August 17, 2023

Memorandum – Budlong Park Pool, Cranston RI – Existing Conditions

Figure 4.5.12.1: Plumb Pool Walls: Cross-Section

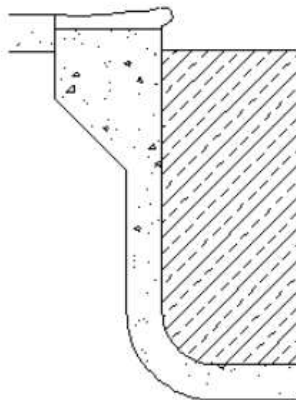
14. On the deep end pool wall there is a wall obstruction. It appears to be part of the pool as the pool was liner-ed over it. This a violation of MAHC [4.5.12.4](#) – No Protrusions, Extensions, Means of Entanglement, or Obstruction. This requires walls to be within +/- 3 Degrees in vertical tolerance. There are areas of the shallow that seem to be more than 3 % of tolerance.

Plumb within a +/- 3 degree tolerance.
